Technical Service Bulletin

90 Front camera for driver assist systems R242 fails to calibrate

90 20 56 2059971/1 July 2, 2020.

Model(s)	Year	VIN Range	Vehicle-Specific Equipment
A6, A7, S6, S7, RS6, and RS7	2019 - 2020	All	Multifunction camera

Figure 2. Placement of decal.

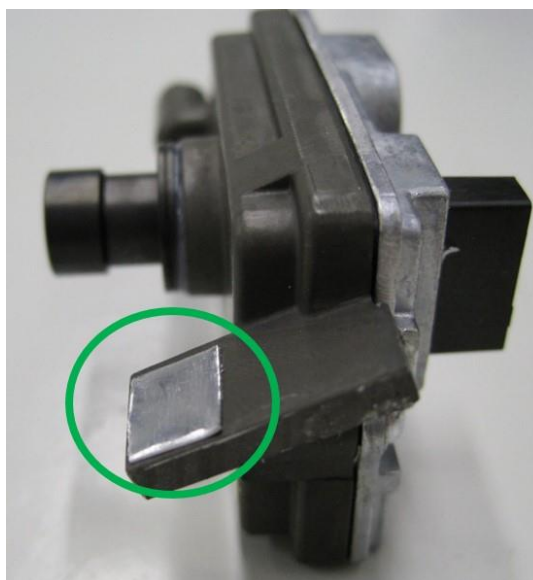
2. An aluminum foil (part number 4K0 907 231 MTR) has to be attached to the windshield to correct the pitch angle of the front camera. Manufacture a 5mmx10mm decal and stick it on the mounting bar of the front camera previously cleaned with Isopropanol (Figure 2 and 3).
